CITY OF CODY
PLANNING, ZONING AND ADJUSTMENT BOARD AGENDA
TUESDAY, FEBRUARY 28, 2023
CITY HALL COUNCIL CHAMBERS @ 12:00 NOON

**CITY OF CODY
PLANNING, ZONING AND ADJUSTMENT BOARD
STAFF REPORT**

MEETING DATE:	FEBRUARY 14, 2023	TYPE OF ACTION NEEDED	
AGENDA ITEM:		P&Z BOARD APPROVAL:	
SUBJECT:	FINAL PLAT AND CONSTRUCTION PLANS FOR THE SUNRIDGE SUBDIVISION—AN 5-LOT SUBDIVISION. SUB 2022-04	RECOMMENDATION TO COUNCIL:	X
PREPARED BY:	TODD STOWELL, CITY PLANNER	DISCUSSION ONLY:

SHEET 1 OF 1

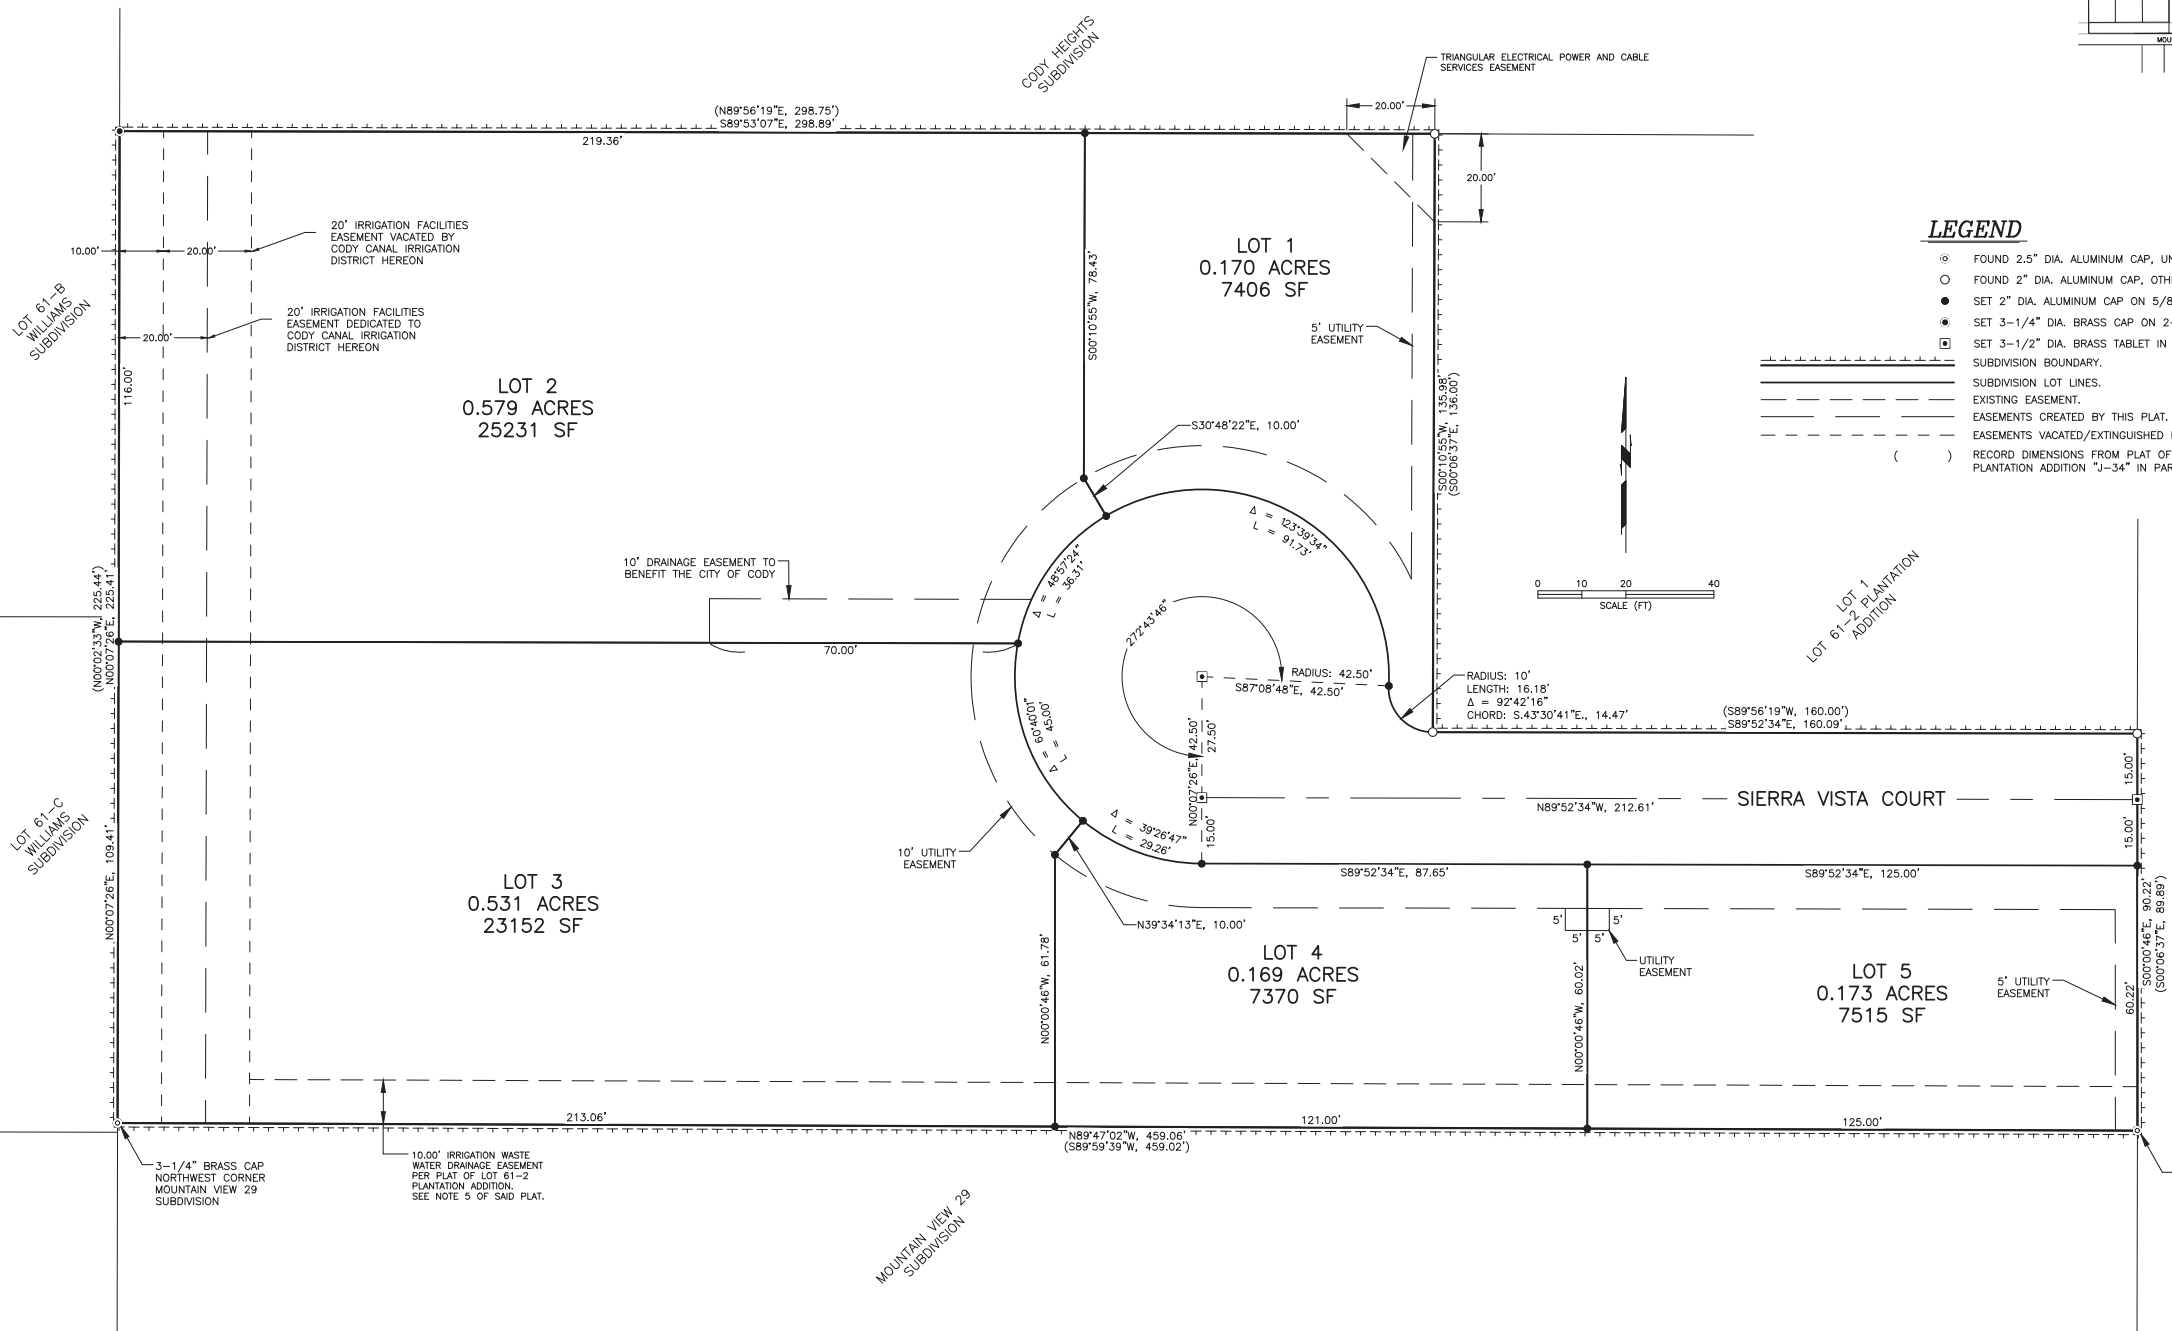
- b) *The street name of "Sierra Vista Court has been approved by the street name committee.* Met, and added to the documents.
- c) *Primary vehicle access for Lot 5 will be limited to the interior street. Include a note on the final plat to notify the lot owner of the restriction.* Met—see Note 2 on Final Plat.

- d) *Add a note to the final plat about each lot providing at least two additional parking spaces above the minimum, due to the restriction of no on-street parking.* Met---see Note 3 on Final Plat.

- m) *Coordinate the street design with the pathway design. Met---see Sheet 7 of plans.*
 - n) *List the variances granted on the final plat. Not met—need to add.*

SHEET
2 OF 11

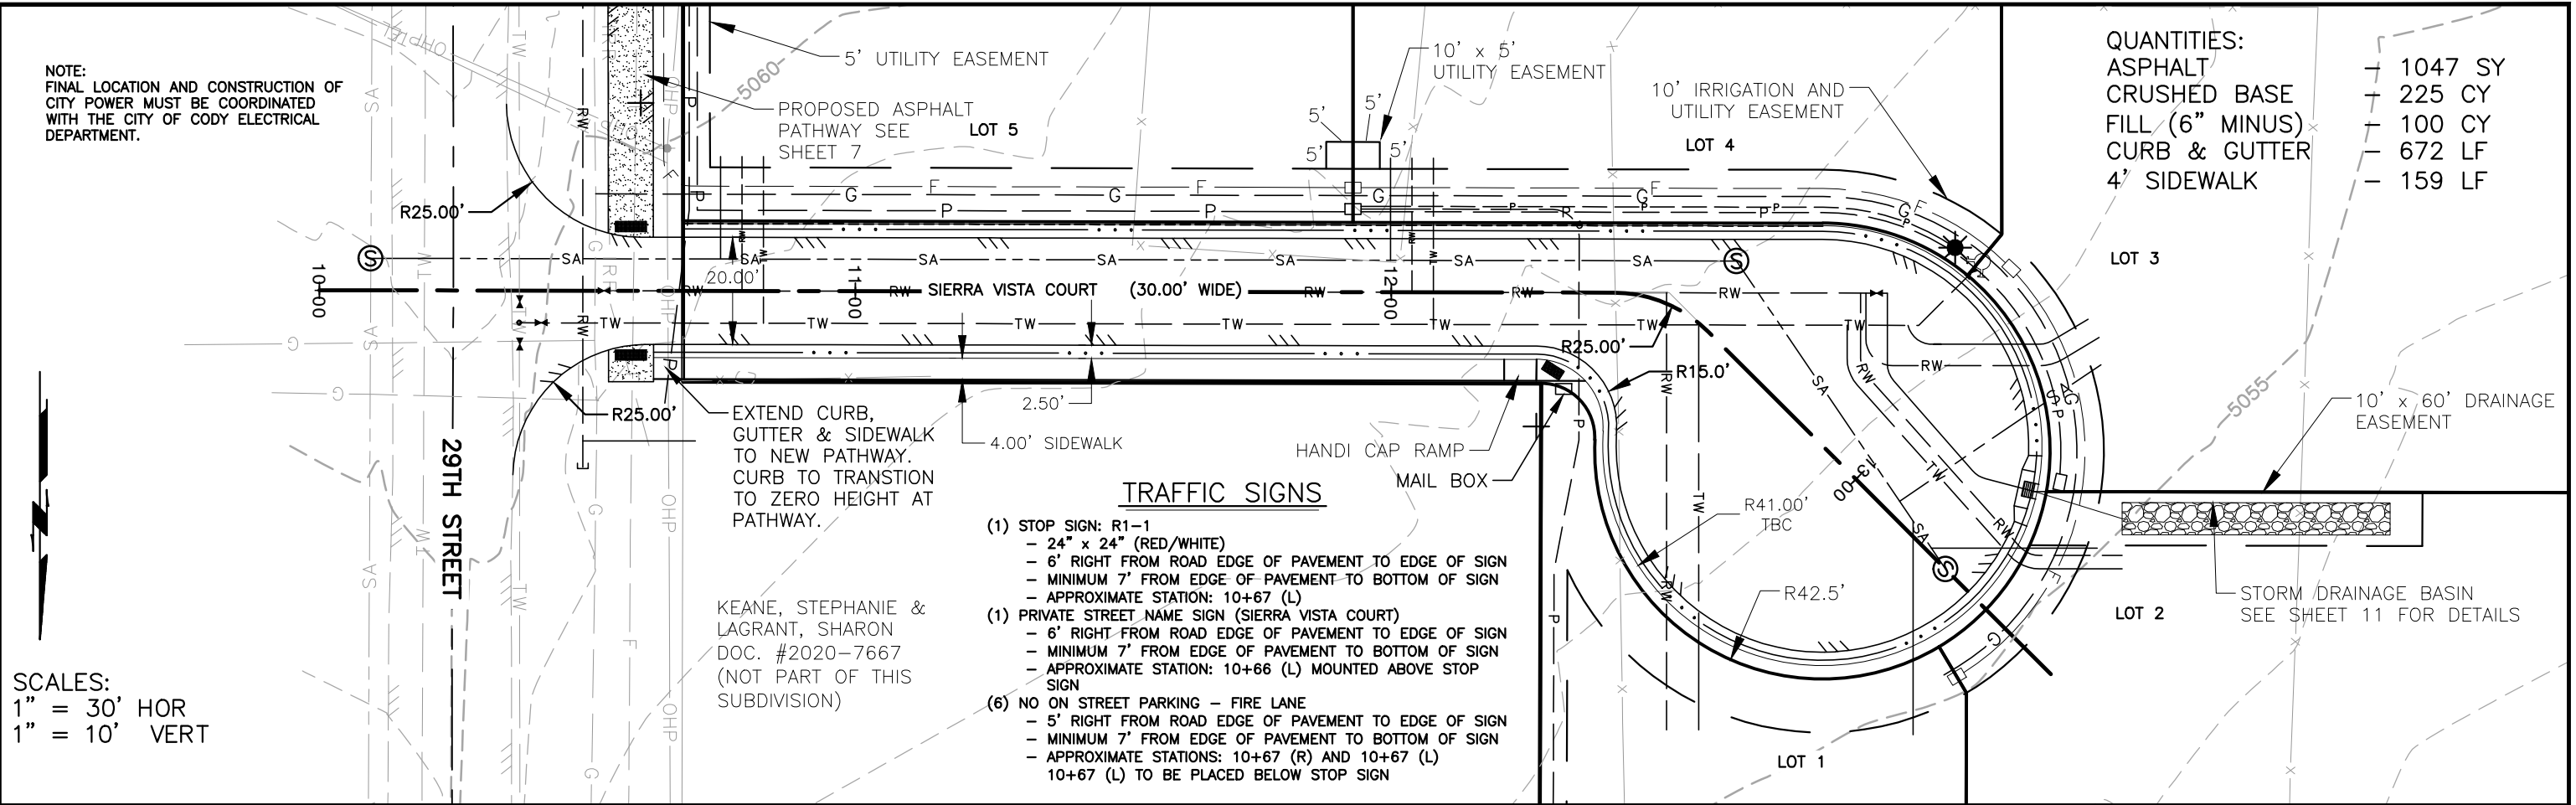
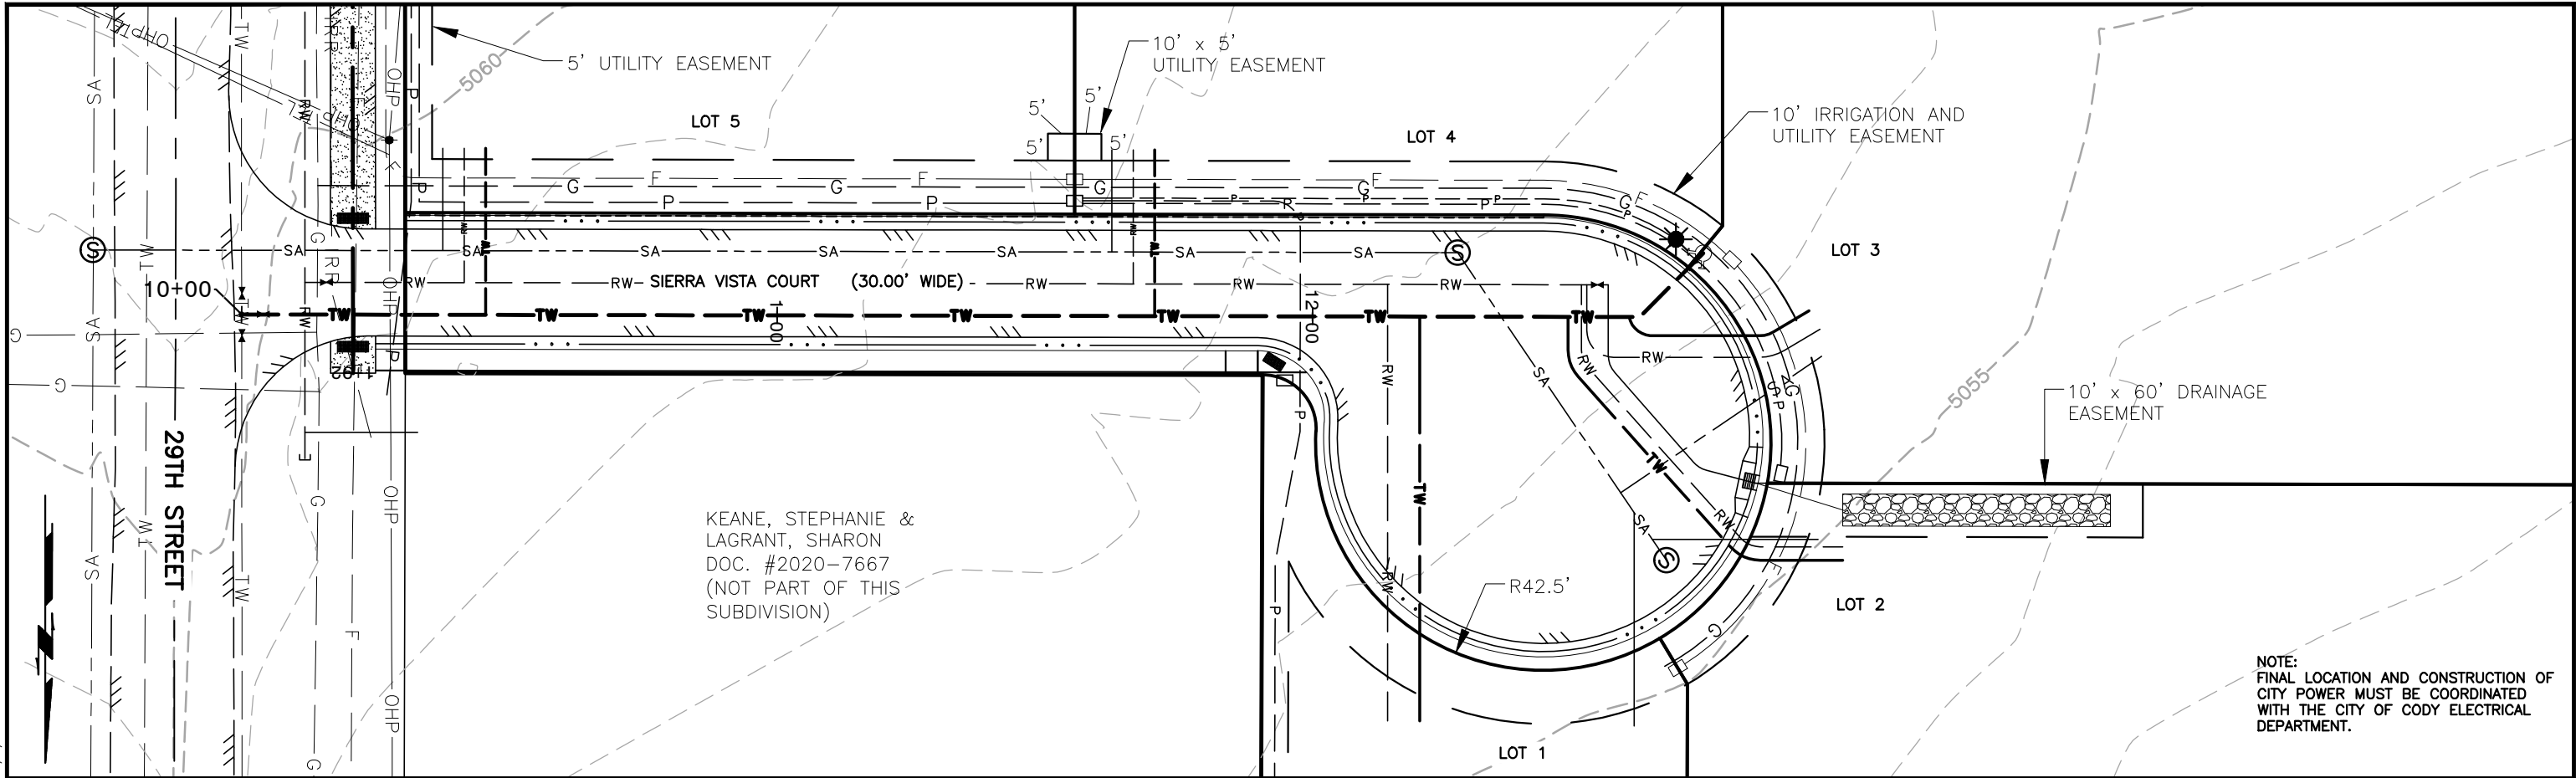
- h) *Provide a cross section detail for the street and utilities. Met—see Sheets 2 and 8-12.*
 - i) *In order to avoid having to dig under the dry utilities to connect to the water service stubs, extend a "pigtail" from the curb stop at the back of the sidewalk (or curb if no sidewalk) under the dry utility trench. Include a detail in the construction plans. Met—see Sheet 8.*
